BEFORE THE AUCKLAND COUNCIL

IN THE MATTER A Notice of Requirement by KiwiRail for the Palmerston North Regional Freight Hub Designation.

**STATEMENT OF EVIDENCE OF MICHAEL NIXON FOR
FOODSTUFFS NORTH ISLAND LIMITED (FSNI)**

(TRANSPORT)

Figure 1: NOR Proposal

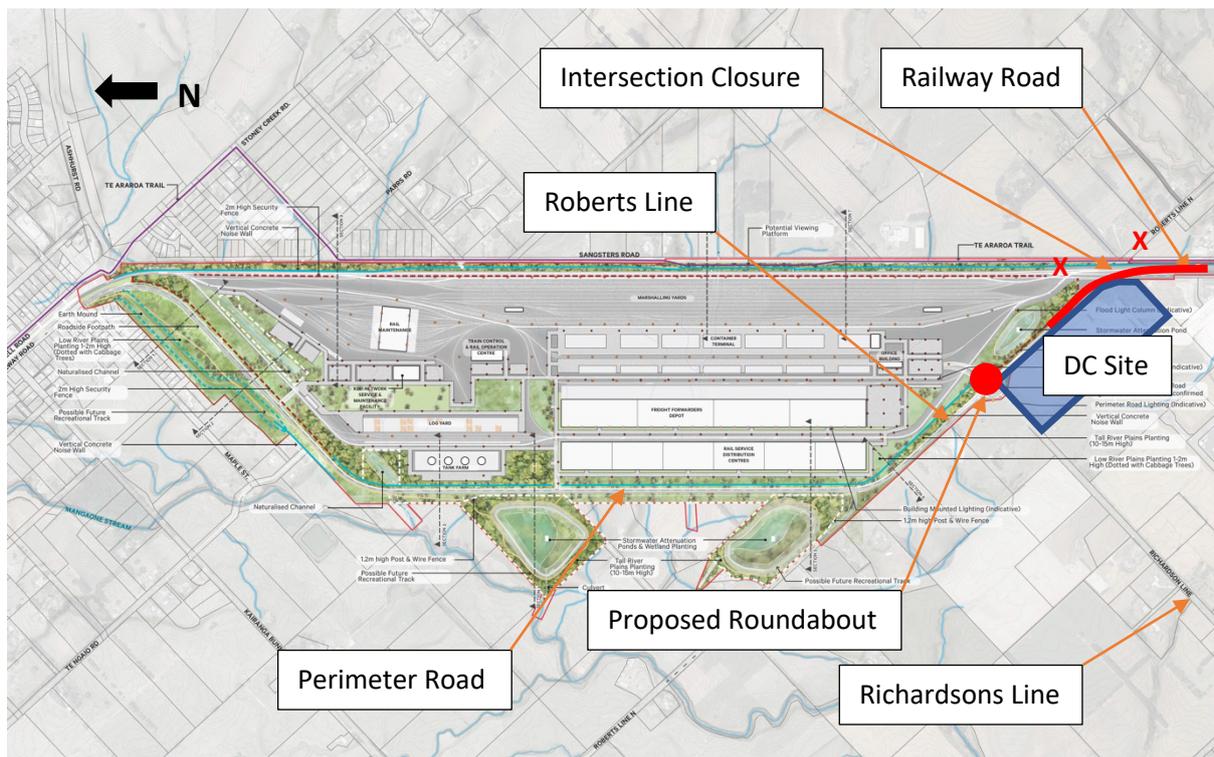
- The geometry of the Railway Road to Roberts Line road alignment, specifically the effects on available sight distances at the DC site vehicle crossings (visibility to the east);
- The closure of Railway Road north of Roberts Line and the re-direction of traffic in front of the DC site. I am concerned that with the increase in volumes in front of the DC site, the safe and efficient operation of the DC site vehicle crossings may be compromised;
- The NOR requirement for land to be taken from the DC site to facilitate construction of the Roberts Line/ Richardsons Line roundabout. I am concerned that alternative options to avoid taking land from the DC site have not been fully investigated.

- 3.2. As shown in Figure 1, the NOR proposal plans to close Railway Road to the north of Roberts Line, and Roberts Line to the east of Railway Road (including closing the existing level crossing). Essentially, Railway Road south of the intersection will continue into Roberts Line west of the intersection (a mid-block curve will link the two roads and the crossroads intersection will no longer exist).

Figure 2: Proposed Road Geometry between Railway Road (south) and Roberts Line (west)

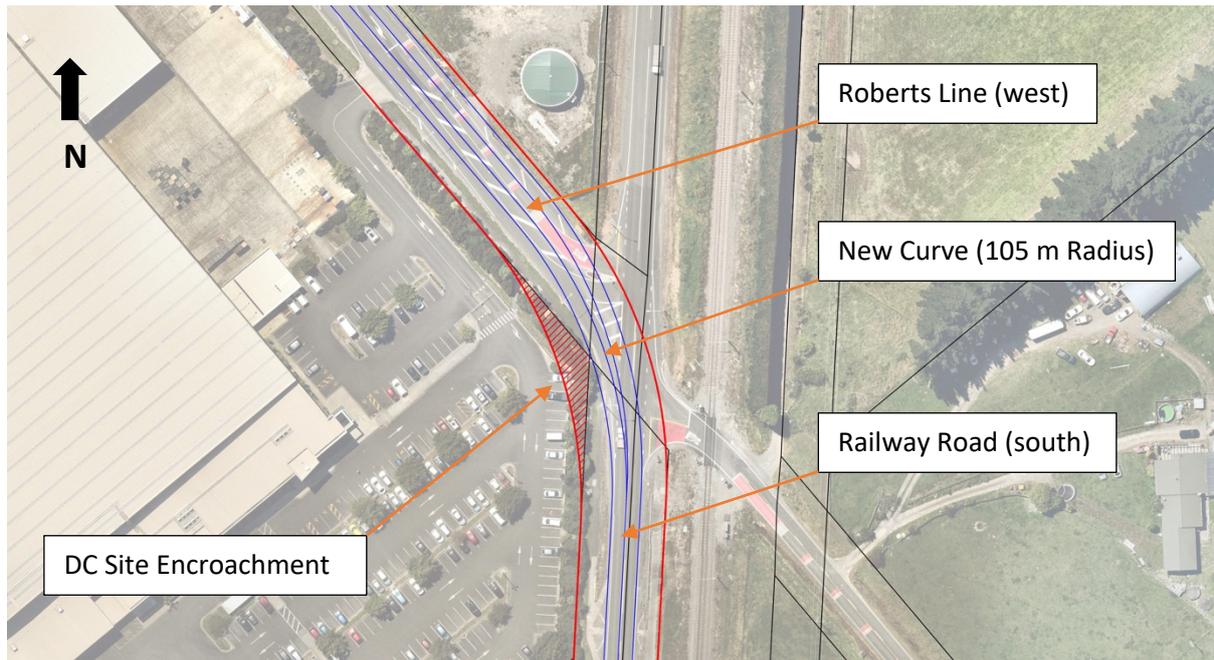
- 3.5. I have assumed a standard crossfall of 3% (not adverse crossfall) and a speed of 60 km/hr. The friction factor (f) depends on vehicles speeds and for 60 km/hr, a value of 0.24³ is the 'Desirable maximum' for cars and the 'Absolute maximum' for trucks. As such, I consider that an appropriate friction value for assessment purposes. The resultant curve radius from the above values i.e. the indicative curve radius between Railway Road (south) and Roberts Line (west), is 105 m.
- 3.6. I have examined what a 105 m radius curve (measured along the centreline) would look like and this is shown in Figure 2.

3.7. This encroachment is very similar to the NOR proposal shown in Figure 3.

Figure 3: NOR Proposal Designation Extent

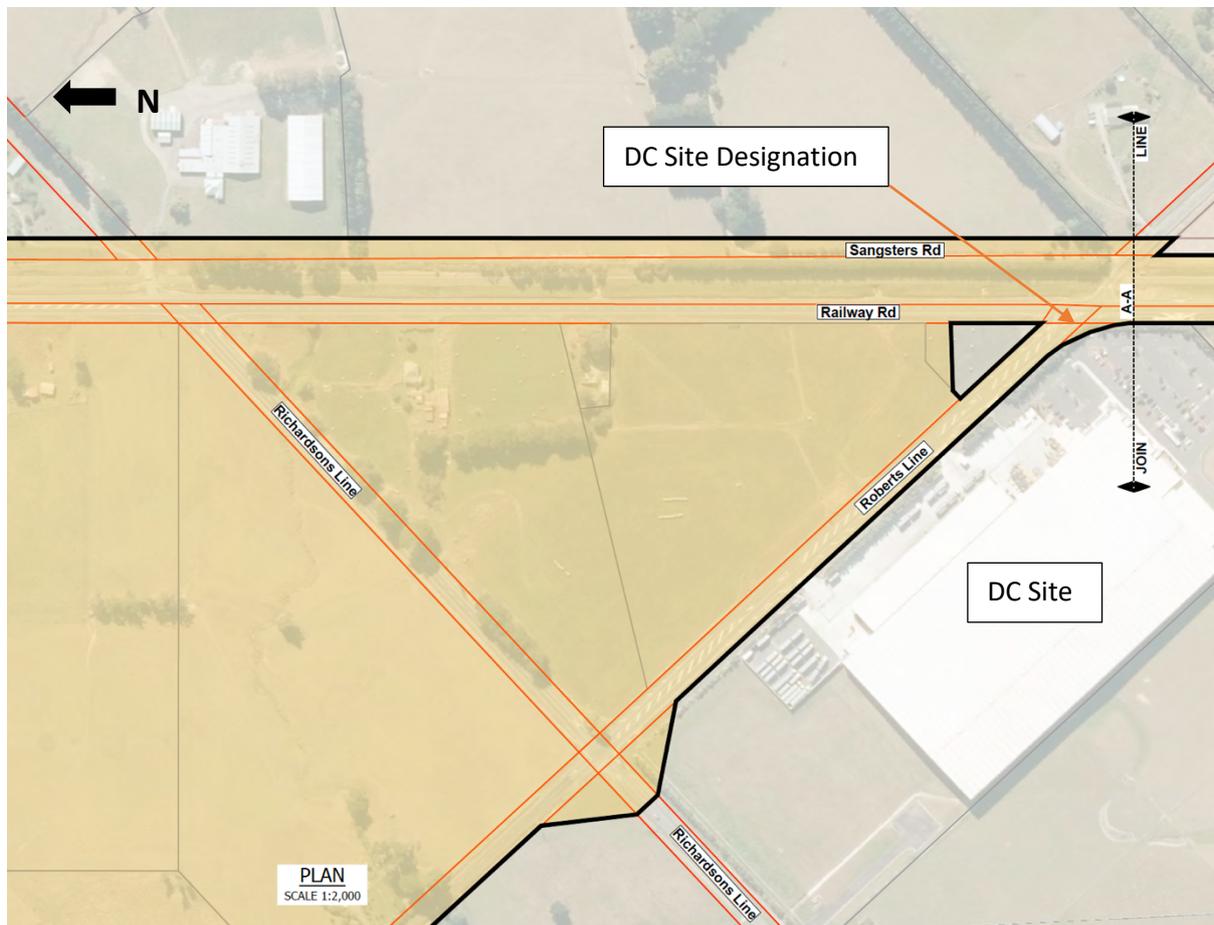
- 3.8. As such, I consider that my estimates of curve geometry are similar to that likely estimated in the NOR proposal, and that overall, 60 km/hr is an appropriate speed for assessing sight distance requirements.
- 3.9. The required sight distance for 60 km/hr varies depending on standards used. I typically use RTS-6 and Austroads standards on roads with speed limits less than 70 km/hr (generally RTS-6 for private vehicle crossings and Austroads standards for public road intersections). I have also assessed against PNCC sight distance requirements⁴. The sight distance requirements are summarised in Table 1 below.

- 3.10. I consider that the available sight distance from the DC site staff vehicle crossing (the vehicle crossing closest to Railway Road) is 95 m, and as a minimum should provide 115 m. As such, I do not consider adequate sight distance can be provided without further implications to the DC site (such as removal of screening vegetation on Roberts Line and Railway Road, and removal of staff car parking to provide a clear sight line to the east).

- 3.11. Overall, I consider there needs to be greater assessment of sight distances (particularly visibility to the east from the staff access) in order to ensure safe vehicle movements can be provided to and from the DC site. The assessment needs to include identifying, for example, what existing planting needs to be removed on the Railway Road and Roberts Line frontages to achieve required sight lines, and what the implication of reinstating that planting is to the operation of the existing staff car park. I am not satisfied that KiwiRail has presented a design that demonstrates safe sight distances can be provided at the DC site vehicle crossings, nor demonstrated that the NOR designation extent is sufficient to accommodate a safe access solution.

Figure 4: Roberts Line/ Richardsons Line Intersection Designation Extent

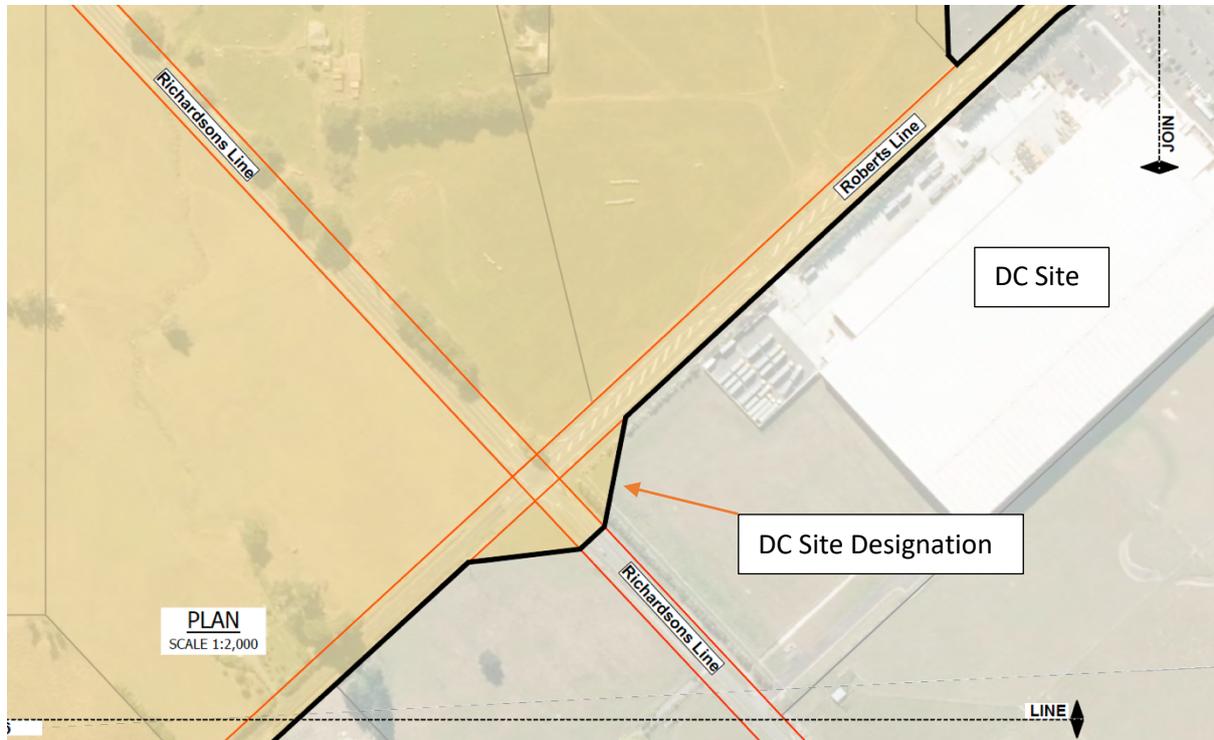
3.18. The purpose of the designation at the Roberts Line/ Richardson Line intersection is to accommodate a four-leg roundabout as indicated in the Landscape Plan⁷. I have no fundamental concerns with a roundabout intersection at this location, and it appears, based on the evidence of Ms Fraser⁸ that PNCC are committed to the upgrade of the intersection regardless of the proposed freight hub.

3.19. Regardless of PNCC support of an intersection upgrade, given the designation for the intersection is being sought by KiwiRail, I consider that an alternative roundabout design should have been considered that did not require designating a portion of the DC site i.e. a roundabout that was wholly located within the KiwiRail land proposed for the regional freight hub.

3.20. I have not prepared a detailed design of this alternative roundabout but to illustrate the concept, please refer to the example in Figure 5 overleaf. This example roundabout is located at the intersection of SH26 and SH27 in Tatanui (to the east of Hamilton).

3.21. As shown above, SH26 runs parallel to the rail line but then deviates away from the rail line to accommodate the roundabout. I am suggesting a similar solution may be able to be found at the regional freight hub by deviating Roberts Line away from the DC site, and into the KiwiRail site, in order to accommodate the roundabout.
